Flat-cap garage · white walkway / balcony revision

ELEVATIONS FIRST / Heights from garage ground datum / Concept dimensions, not construction details

REVISION FOR REVIEW

01 WEST ELEVATION · looking east

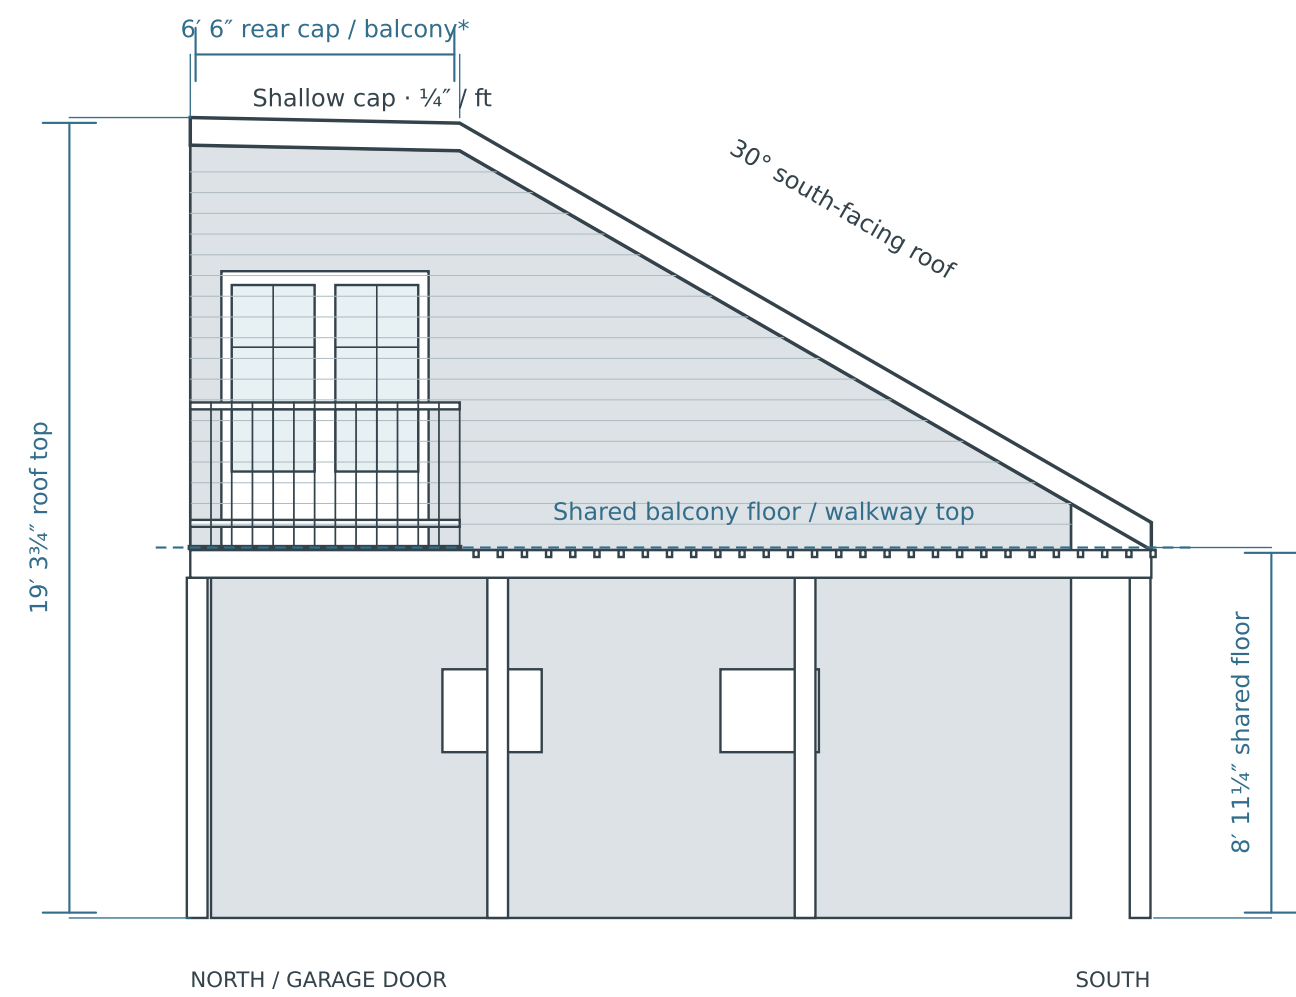
- Rear flat-cap option retained; full-slope option dropped.
- No lattice rises from the walkway to the main roof.
- One west beam/post row: 32 inches from the existing wall.
- Walkway roof and balcony floor share the loft floor level.
- Balcony, fascia, posts and beam shown white.
- Horizontal members over the remaining walkway; solid walking surface beneath the balcony and French doors.

03 WEST WALKWAY / BALCONY SECTION · diagram

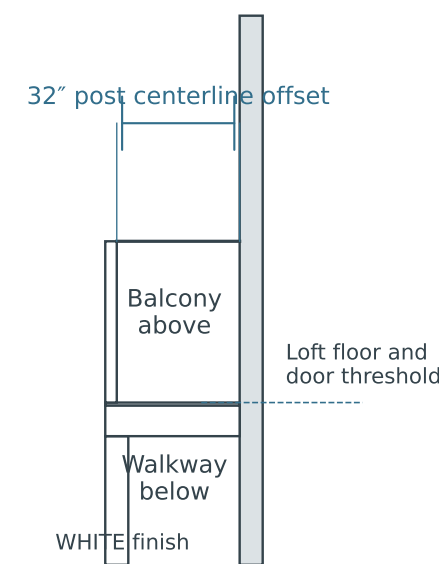
* Provisional: balcony spans the 6 ft 6 in rear zone;
French doors 5 ft × 6 ft 8 in; railing 42 in high.
Existing assumptions retained: 8 in beam + 3/4 in deck.
Assembly thickness, drainage and connections need design.
No new east/south covered passage inferred in this sheet.
